Subject: Boyle Boat Ramp

C.O.E. Application # 2007- 484

(Boyle Boat Ramp & Dock)

Section 7(a) Evaluation, Wild and Scenic Rivers Act

Figure 1. General area of project.

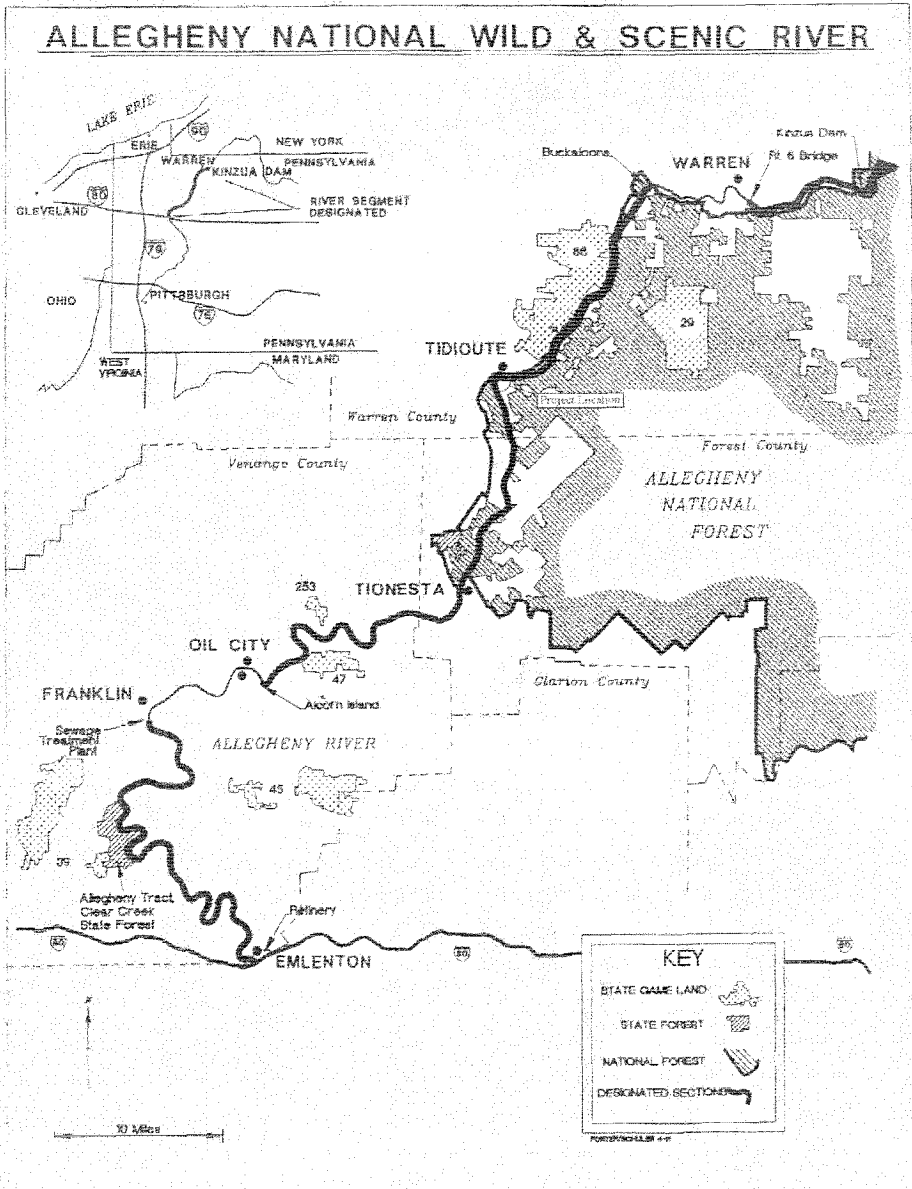
Comment: This project replaces an informal access ramp.
